Coal Energy Group 2
CEG
Wildcat Load Out

Re: **Pond C and E inlet modifications, Coal Energy Group 2, LLC, Wildcat Load Out, Carbon County, Utah, C0070033**

Permittee: Coal Energy Group 2, LLC
Mine: Wildcat Loadout **Permit Number:** C0070033
Title: Pond C and E inlet modifications

SEDIMENT PONDS C AND E
INLET MODIFICATIONS

WILDCAT LOADOUT
PLATE 2A
DRAINAGE MAP

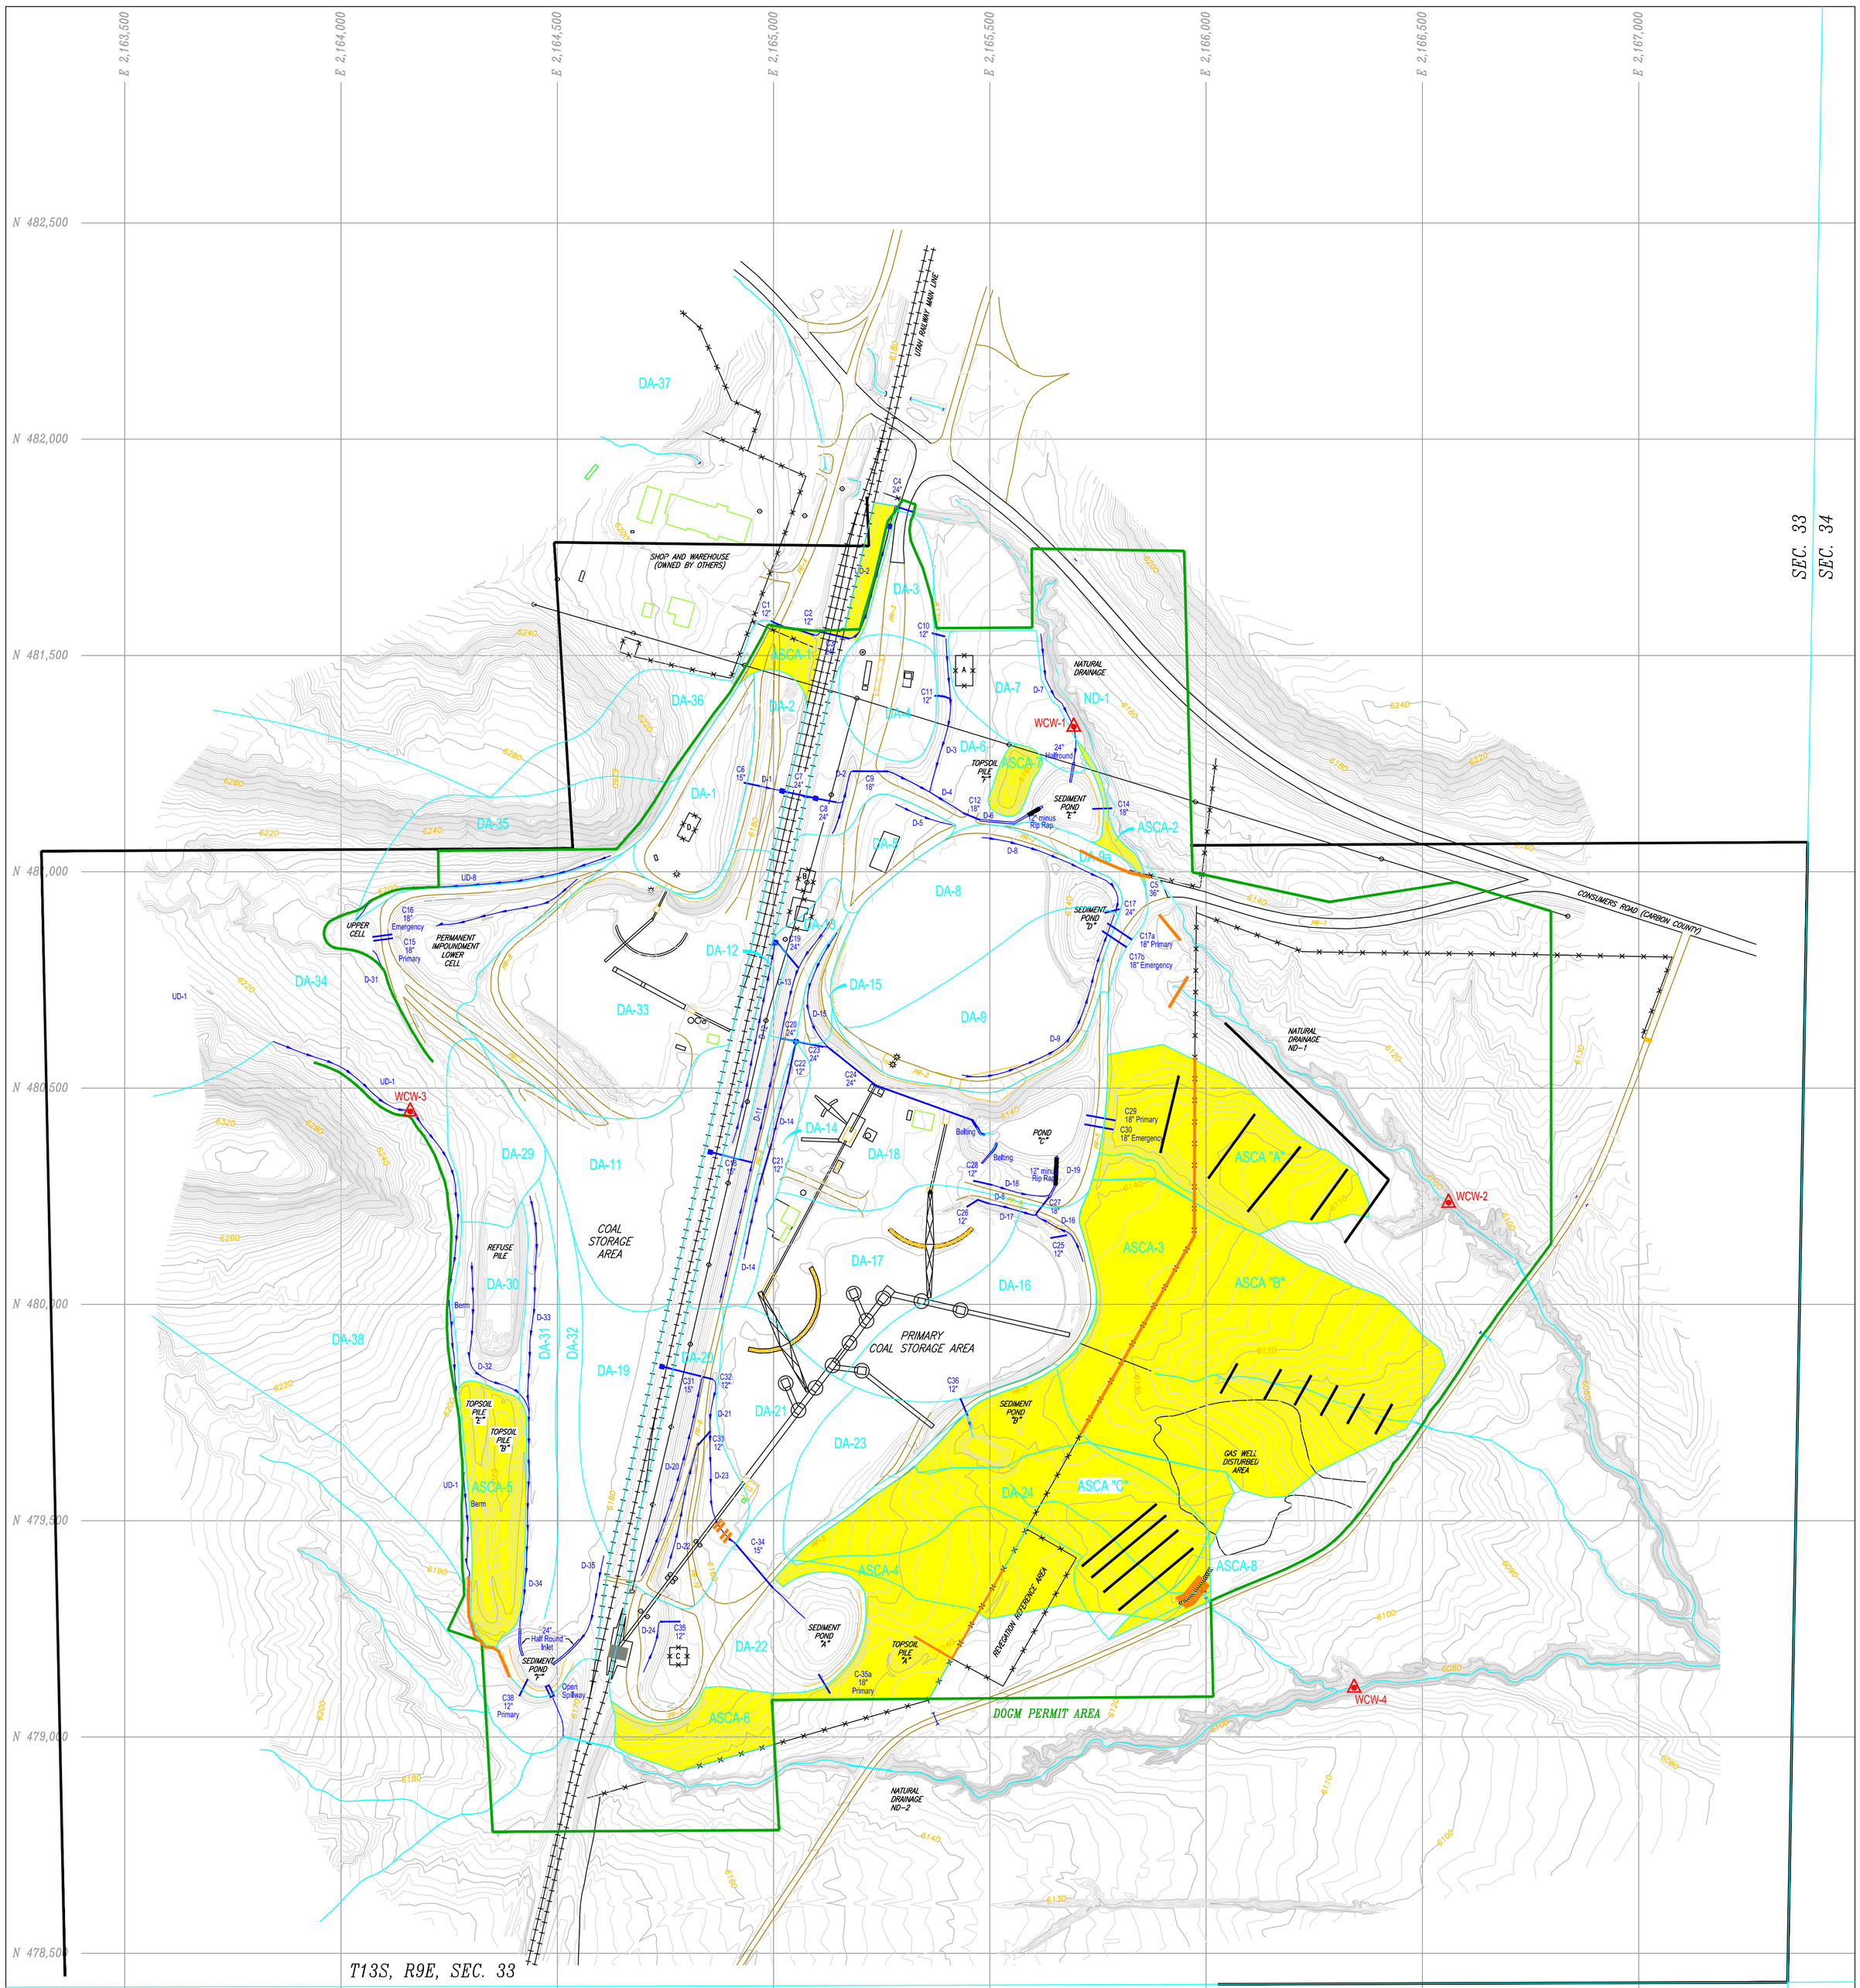
The inlets to Sediment Ponds C and E that were previously fitted with half-round culverts have been modified to provide more adequate erosion control. The half-round culvert into Pond C has been completely removed and replaced with a rock-armored ditch. The half-round culvert in the lower portion of the inlet into Pond E has also been removed and replaced with a rock-armored ditch. The half-round culvert above has been left in place. The new inlet configurations are shown on Plates 2A, 3C and 3E.

I, Dan W. Guy, a Registered Professional Engineer, State of Utah No. 15168, do hereby certify that the modifications to the inlets of Sediment Ponds C and E shown on this revision 6, are true and accurate to the best of my knowledge.

WILDCAT LOADOUT
SEDIMENT POND "C"
EXISTING

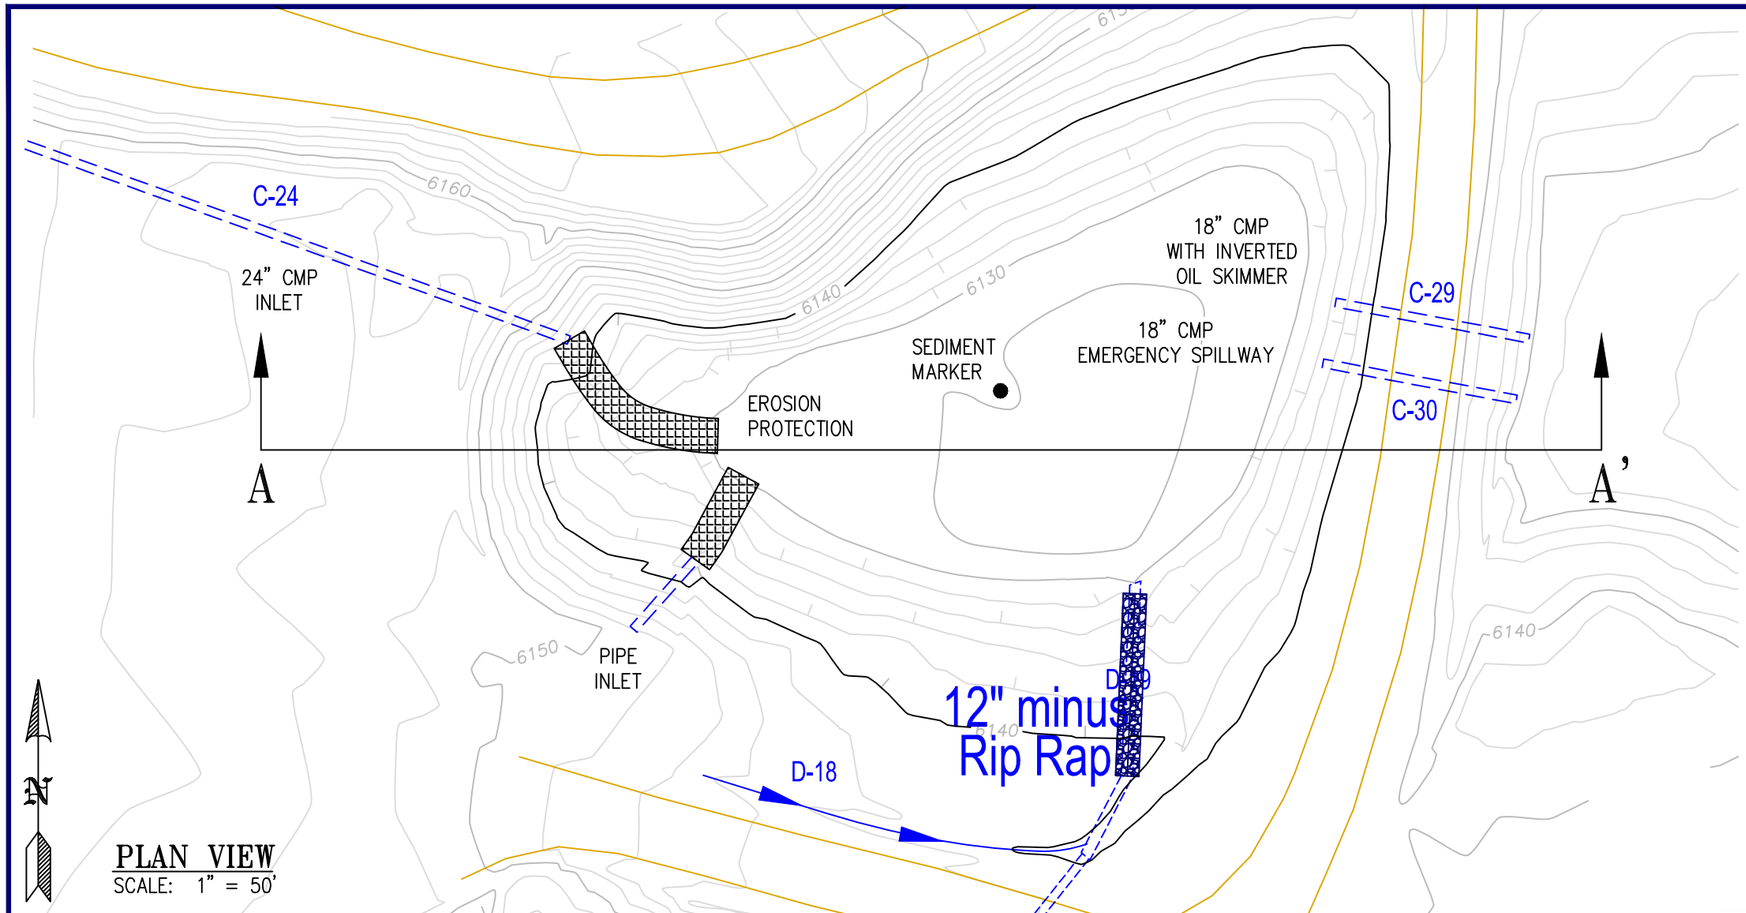
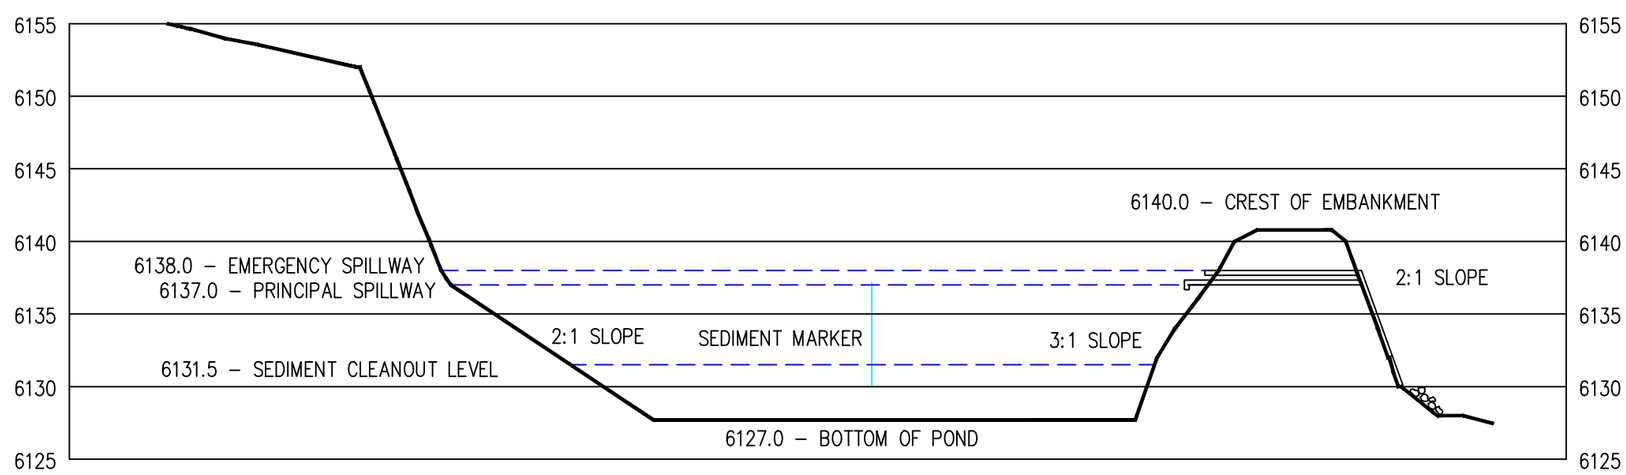
The half-round culvert inlet into Pond C was completely removed. The ditch was then cleaned out and lined with minus 2" bedding material and then completely armored with 12" minus rock rip-rap. The resulting ditch is 6' – 8' wide at the top and approximately 34" deep, which is considerably larger than the culvert area. The modified area is approximately 51' in length with a slope of 12 degrees.

The inflow from a 10 yr. / 24 hr. storm event for this inlet is calculated to be 11.14 cfs with a flow velocity of 6.76 fps, as shown for Ditch D-19 on Table 6 of Appendix R. This flow was checked against the Rip-Rap Chart – Figure 2 in Appendix R. Using a worst-case scenario of 1:1 side slopes and the flow velocity of 6.76 fps, the rip-rap size should be approximately 8". The 12" minus material used is therefore considered adequate to resist displacement.

WILDCAT LOADOUT
SEDIMENT POND "E"
EXISTING

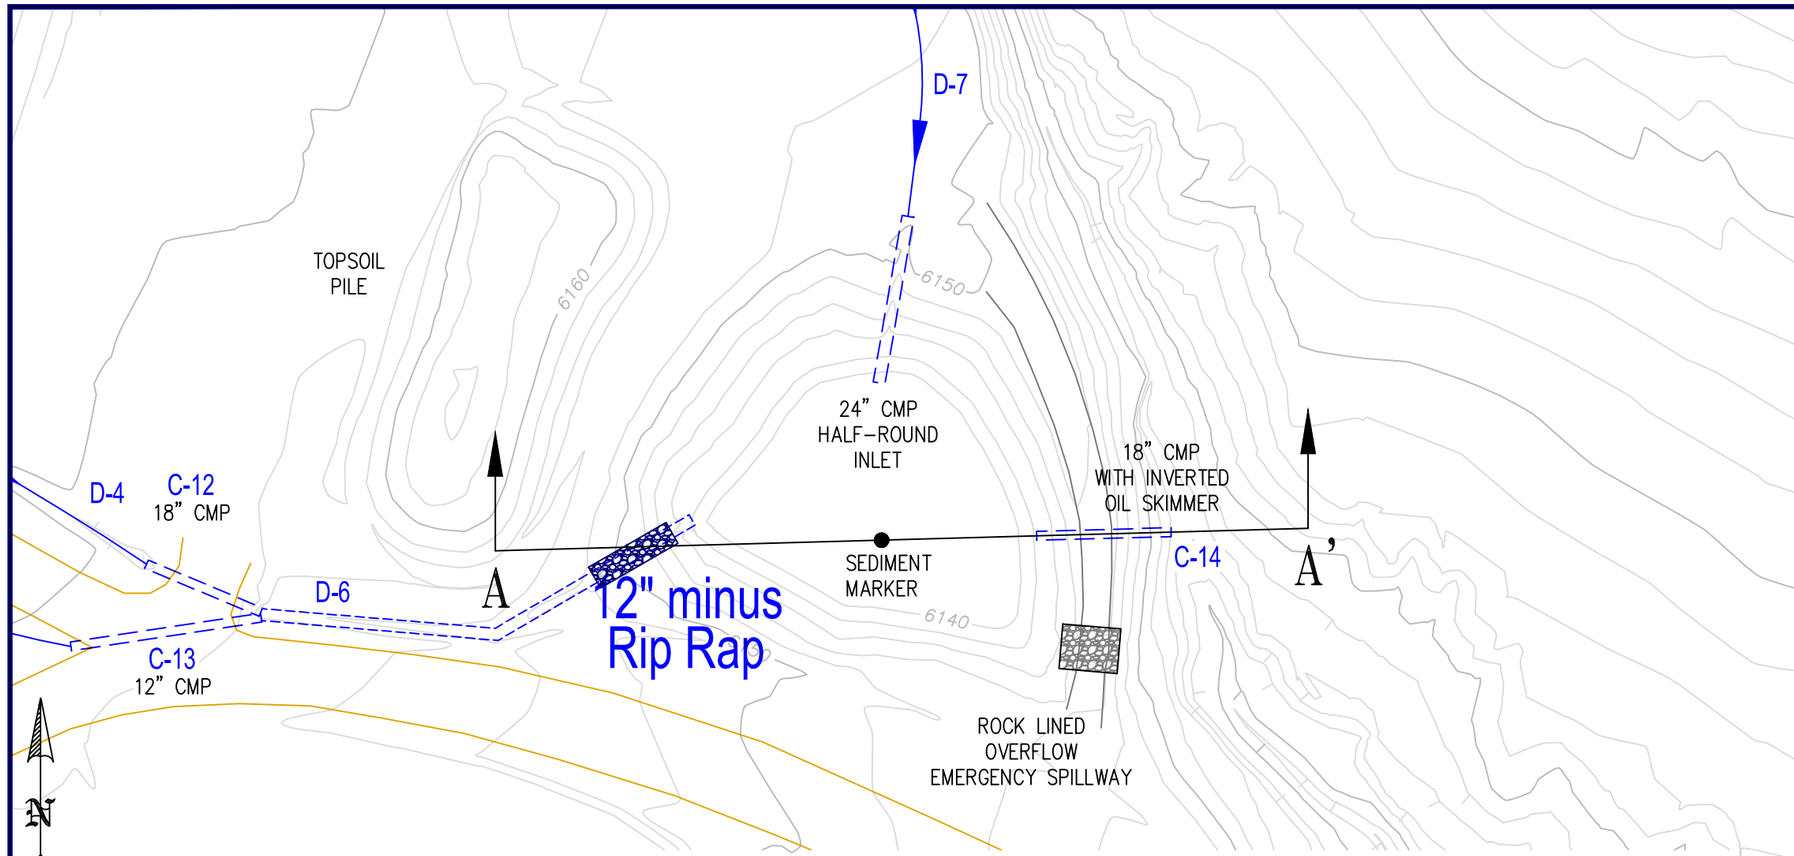
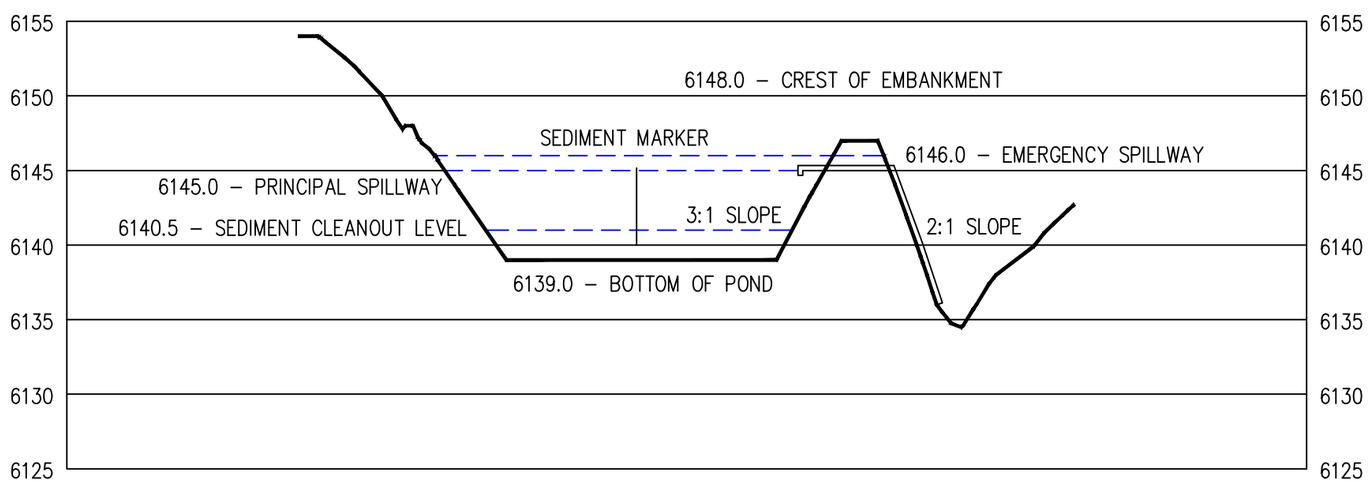
Only the lower portion of the half-round culvert inlet into Pond E has been replaced. This is a relatively small section of approximately 25' in length where the slope steepened and the culvert was being undercut. The modification here was the same as in Pond C above. The culvert was removed and the ditch was cleaned out and reshaped. The ditch was then lined with the minus 2" bedding material and then armored with the 12" minus rock rip-rap. The rip-rapped ditch is 6' – 8' wide at the top and approximately 30" deep, which is also larger than the previous culvert area. The modified area here is approximately 25' in length with a slope of 20 degrees.

The inflow from a 10 yr. / 24 hr. storm event for this inlet is calculated to be 7.77 cfs with a flow velocity of 6.07 fps, as shown for Ditch D-6 on Table 6 of Appendix R. This flow was also checked against the Rip-Rap Chart as mentioned above. Using the worst-case scenario of 1:1 side slopes and the flow velocity of 6.07 fps, the rip-rap size should be approximately 6". The 12" minus material used is also considered adequate to resist displacement in this modified inlet.
